**STAFF REPORT**  
**COMMUNITY DEVELOPMENT DEPARTMENT**

HEARING DATE: 09/10/2024  
TO: Mayor & City Council  
FROM: Nick Napoli, Associate Planner  
208-884-5533  
SUBJECT: Apex Northwest No. 5  
FP-2024-0017  
LOCATION: Near the northwest corner of S. Locust Grove Rd. & E. Lake Hazel Rd., in the SE ¼ of Section 31, Township 3N., Range 1E.

Final Plat consisting of 40 single family building lots and eleven (11) common lots on 16.40 acres of land in the R-8 zoning district for the Apex Northwest Subdivision No. 5.

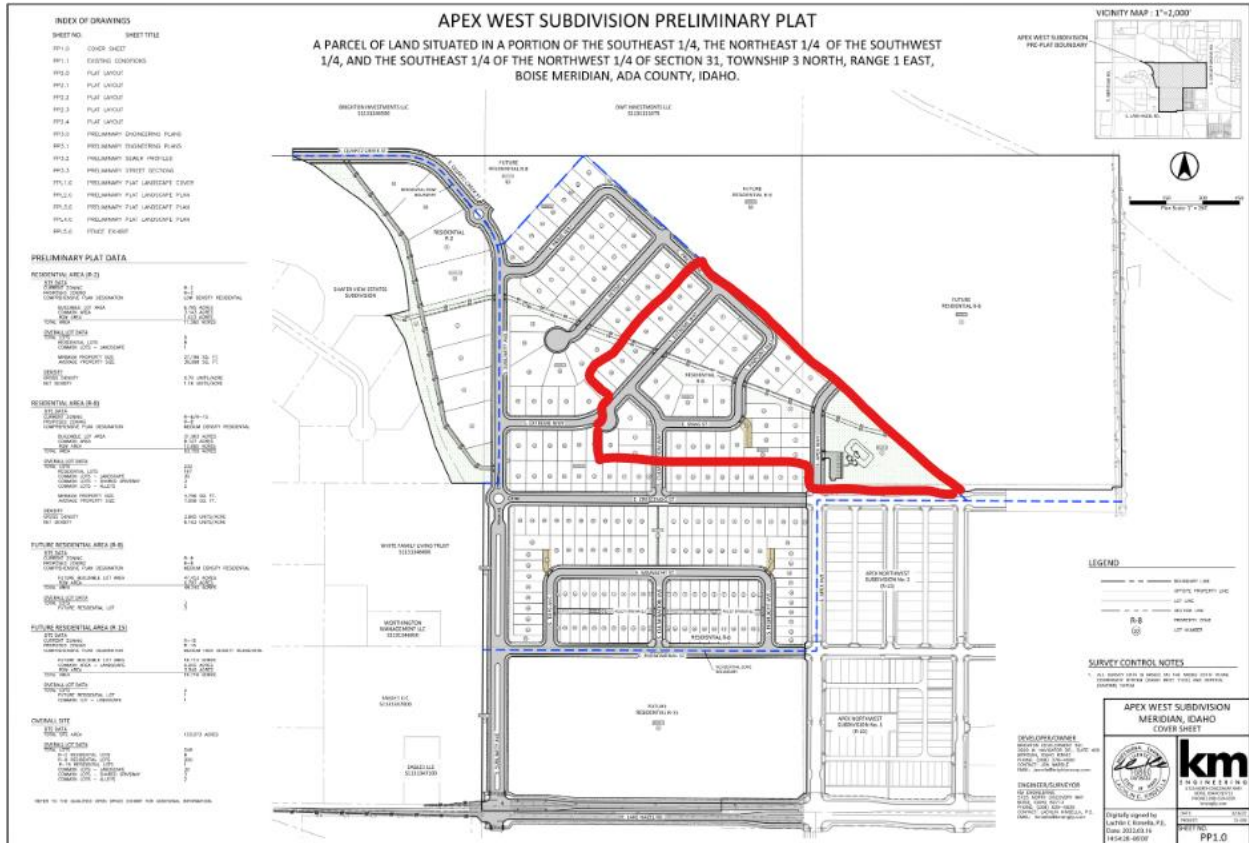
In order for the proposed final plat to be deemed in substantial compliance with the approved preliminary plat as set forth in UDC 11-6B-3C.2, the number of buildable lots cannot increase and the amount of common area cannot decrease. However, the road alignment and lot configuration have changed slightly from the preliminary plat. This is due to S. Apex Way being designated as a collector which does not allow direct lot access. Since there is no change to the number of buildable

lots and the amount of common open space is the same, therefore, Staff deems the proposed final plat to be in substantial compliance with the approved preliminary plat as required.

B. Final Plat (dated: 05/29/24)

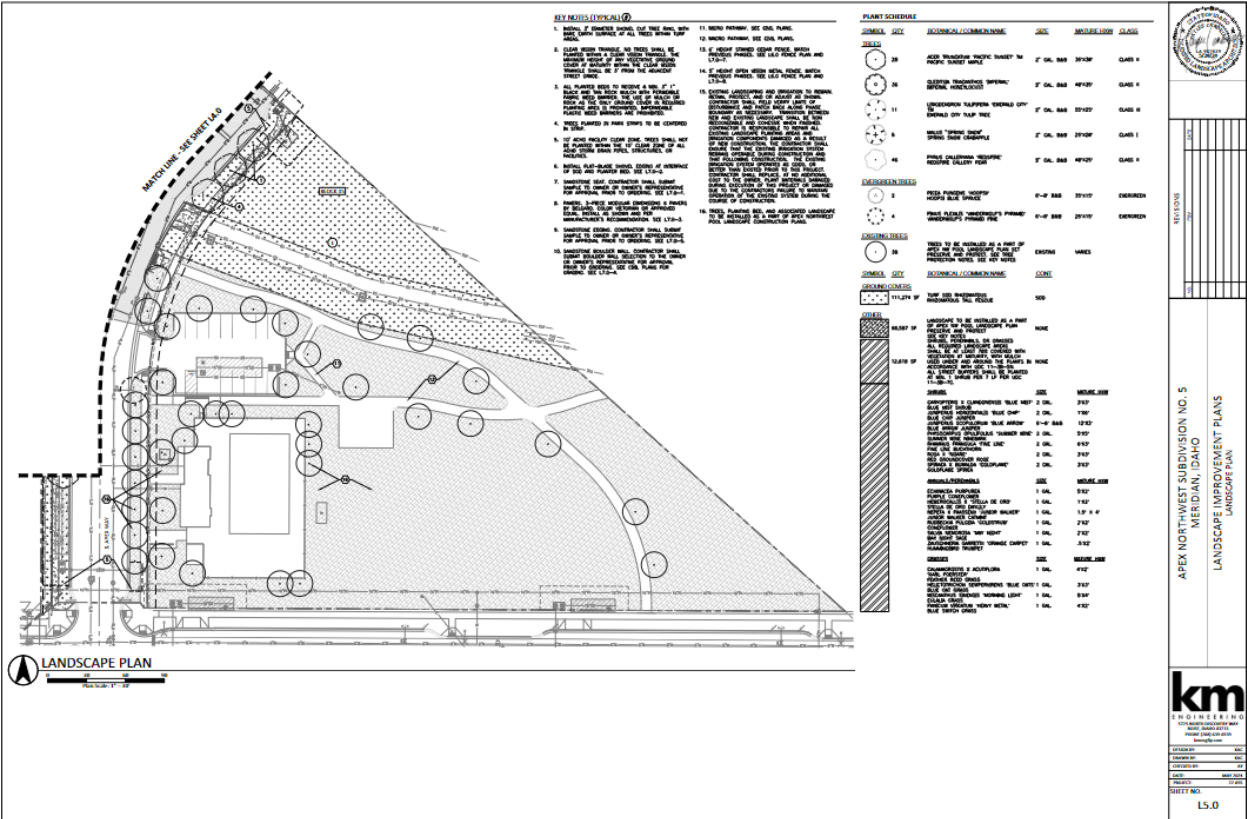
- a. Note #10: Include the recorded instrument numbers for the ACHD right of way easement.
  - b. Note #17 and 18: Include the recorded instrument number of the ACHD sidewalk easement.

- c. Note #16: Include the recorded instrument number of the City of Meridian Sanitary Sewer and Water Easement.
  - d. Lot 15, Block 10 shall be extended through Lot 14, Block 10 and Lot 19, Block 10 shall be extended through Lot 20, Block 10 to depict identical building setback envelopes shown on adjacent properties. The intent behind this is to prevent residents from backing

down the common lot out of their garage. Please depict on an updated common drive exhibit.

- e. Replace the street name for “S. Highmark Way” with “S. Highmark Avenue” in accordance with the Ada County Street Name Review.

*A copy of the revised plat shall be submitted with the final plat for City Engineer signature.*
